<b>Title:</b>	Startare Residential Rehabilitation and Façade Alterations
<b>Project:</b>	Historic Preservation HP-25-11
<b>Location:</b>	1627 Pine Street
<b>APN:</b>	004-071-015
<b>Applicant:</b>	William Startare
<b>Property Owner:</b>	William Startare and Erik Strombeck
<b>Purpose:</b>	After-the-fact approval of exterior façade alterations to rehabilitate a multi-family residence, including changes to siding, trim, doors, windows, porches, and lighting.
<b>Complete Application:</b>	February 11, 2026
<b>Deadline for Action:</b>	May 12, 2026
<b>General Plan:</b>	HDR – High Density Residential
<b>Zoning:</b>	R3 – Residential High
<b>California Environmental Quality Act (CEQA):</b>	If approved (or conditionally approved), then exempt under CEQA Guidelines §15331, Class 31 Historical Resource Restoration/Rehabilitation; if denied, then CEQA does not apply per CEQA Guidelines §15270.
<b>Staff Contact:</b>	Chris Lohofener, Senior Planner

**Figure 11: Church Street Façade, Alcove, Post-Rehabilitation, 2025.**

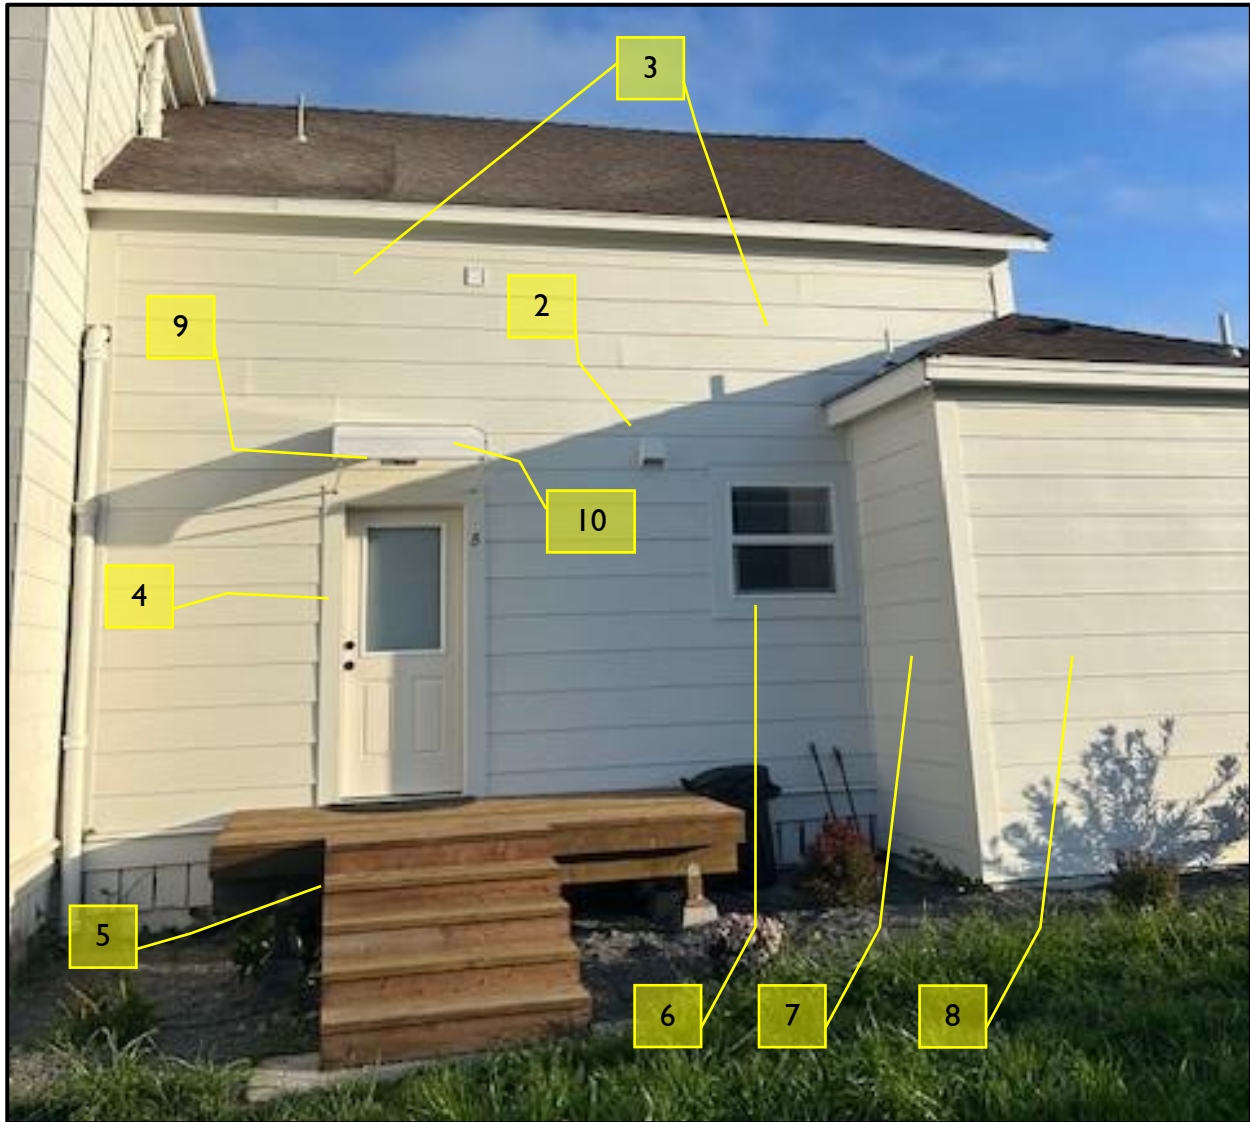
3. Hardie lap siding has been installed throughout the alcove in place of the previous wood lap siding (Figure 11).
4. Based on the 2024 real estate listing floor plans and archived photos, a double-hung wood window assembly, consistent with other windows on the residence, previously occupied this alcove wall area. That window assembly has been removed and replaced with a new doorway, including new half-light fiberglass door with round black doorknob, 1x4 trim, and aluminum threshold (Figures 9 and 11, also see Attachment 2 for floor plans and interior photos depicting room layout).

5. A new pressure-treated wood deck on pier blocks has been constructed beneath the new doorway. The Applicant reports that an older landing was replaced in this location, however, available photos show a window opening and a large shrub rather than a prior landing (Figures 9 and 11).

6. The original window opening appears to remain, but the historic wood sash window has been replaced with a modern vinyl unit. The original wood casing and projecting sill have been removed and replaced with flat 1x4 trim (Figure 11).

7. According to the 2024 real estate listing floor plans, a 30-inch doorway previously existed at this location, likely with associated trim details. The Applicant reports that the door had been removed and the opening boarded prior to his ownership. This doorway has now been removed and infilled with Hardie lap siding (Figures 9 and 11).

8. A window opening approximately 6 feet by 5 feet, with projecting trim, previously occupied most of this wall. It is unclear whether this window was original to the building. The Applicant reports that the window had been “smashed out” and boarded prior to his ownership, and the opening has since been removed and covered with Hardie lap siding (Figures 9 and 11).

9. A new light fixture has been installed above the new doorway in the alcove. (Figures 11 and 12). It is unclear whether the fixture complies with the City’s Dark Sky regulations; if not, it must be brought into compliance.

10. The awning was installed as part of the rehabilitation but has since been removed. The Applicant stated that he intends to develop a different design to protect the entryway – any new exterior alteration will be conditioned for HPC approval.

**Figure 14: Alley Façade, Post-Rehabilitation, 2025.**

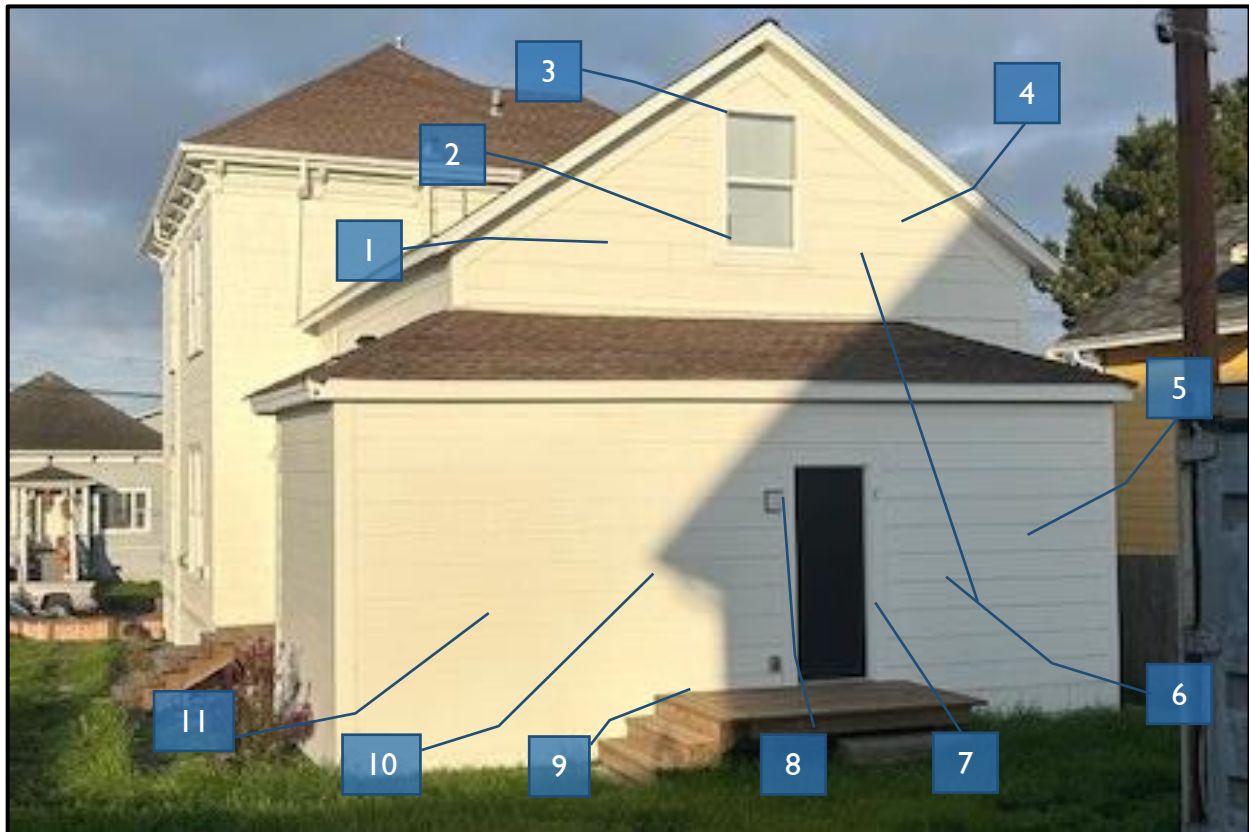
1. It is unclear if the original window had been replaced prior to the current owner, but the window opening, wood casing, and projecting sill have been removed and infilled with Hardie lap siding.
2. It is unclear if the door and balcony feature were original or historic components of the home. However, the door and wood casing were removed, as well as the small balcony and railing.
3. A modern vinyl window unit and flat 1x4 trim, as well as Hardie lap siding, were installed in place of the removed door and balcony described above.
4. It is unclear if the original window had been replaced prior to the current owner, but the window opening, wood casing, and projecting sill have been removed and infilled with Hardie lap siding.
5. The original double-hung wood sash window unit, wood casing and projecting sill have been removed and infilled with Hardie lap siding.

6. Hardie lap siding and new corner trim has been installed throughout the rear façade in place of the previous wood lap siding.
7. The door opening appears to remain in place, but the door and wood casing have been removed. In its place is a modern wood slab door with flat 1x4 trim and a black round doorknob.

8. A new light fixture has been installed above the new doorway in the alcove. (Figures 12 and 14).
9. The deteriorated landing and overhang were removed and a new pressure-treated wood deck on pier blocks has been constructed beneath the new doorway.

10. It is unclear if the original window had been replaced prior to the current owner, but the window opening, wood casing, and projecting sill have been removed and infilled with Hardie lap siding.

11. It is unclear if the original window had been replaced prior to the current owner, but the window opening, wood casing, and projecting sill have been removed and infilled with Hardie lap siding.
